UNITED STATES PATENT AND TRADEMARK OFFICE

10/760,531

Office Action Summary

DETAILED ACTION

Fig. 5

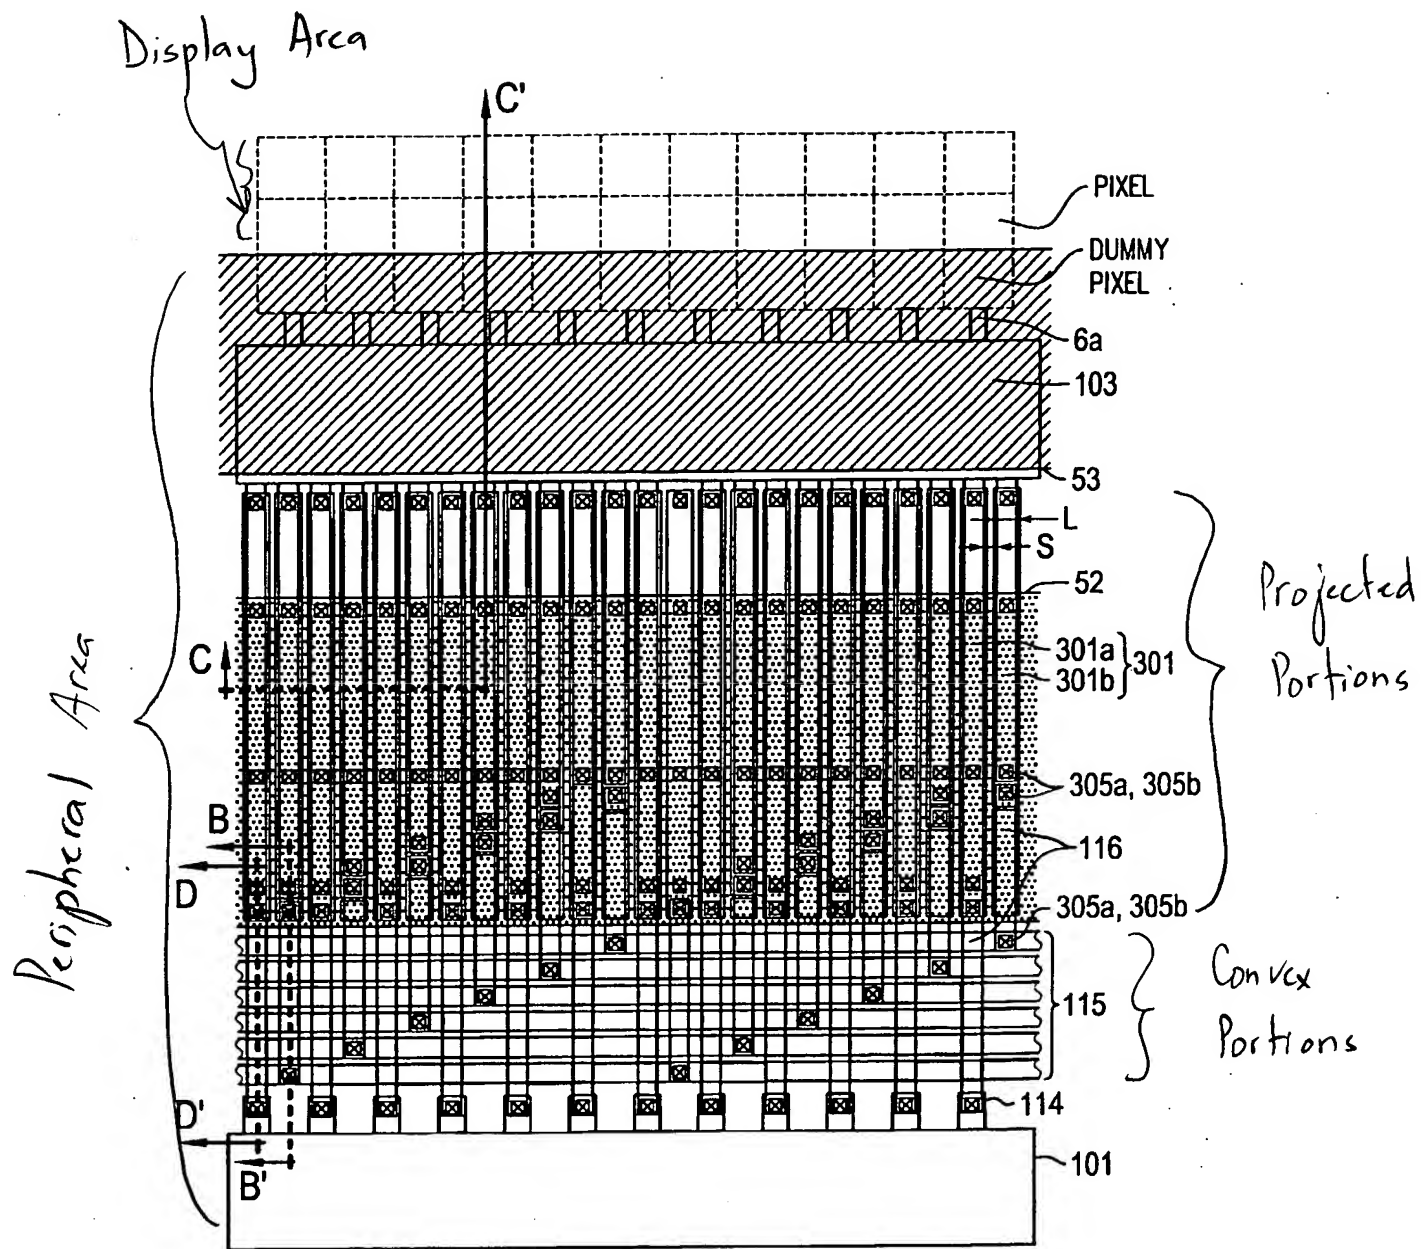
the substrate 10 having an image display area (pixels on top of Fig. 5) defined as an area to form the pixel electrodes 9a and the switching elements 30 (Fig. 1), and a peripheral area defining the periphery of the image display area where a shielding film 53 is a part of the peripheral area (see also Fig. 15), the alignment film 16 being formed in the image display area, and convex portions (on top of image data lines 115 in Figs. 5 and 6) in being formed in at least a part of the peripheral area.

Re claim 2, as shown in Fig. 5, the electro-optical device of Murade further comprises a driving circuit 101 on the substrate 10,

Re claim 3, as shown in Fig. 5, the electro-optical device of Murade further includes a dummy pixel forming area formed outside the image display area, the convex portions being formed outside the dummy pixel forming area.

Re claim 4, as shown in Figs. 5 and 6, Murade discloses that projected portions on top of wirings 301 caused by the extended data lines 301 are formed in an insulating layer 7 (col. 18, lines 44-49), and

Re claim 5, as shown in Figs. 5 and 7, Murade discloses that projected portions caused by the height of the data lines 301 are formed in an insulating layer 7, and

Re claim 8, as shown in Fig. 5 of Murade, the pitch between the linear convex portions is equal to the pitch between the projected portions.

the convex portions are formed along one side (horizontal side) of the image display area as shown in Figs. 4 and 5.

Fig. 6

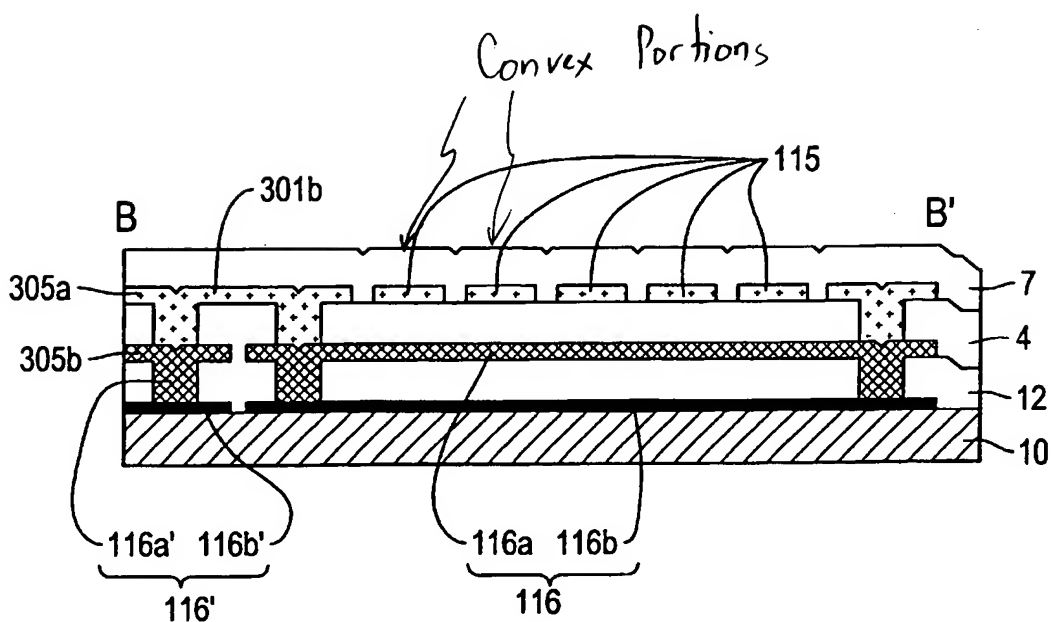
the height of the convex portions is equal to the height of the projected portions as shown in Figs. 6 and 7.

Re claim 6, as shown in Figs. 1 and 6, Murade discloses that the convex portions are formed parallel to the direction in which the data lines 115 extend (col. 8, lines 44-49).

Re claim 7, as shown in Figs. 1 and 6, Murade discloses that the convex portions including a plurality of linear convex portions which are formed along the direction in which the data lines 115 extend.
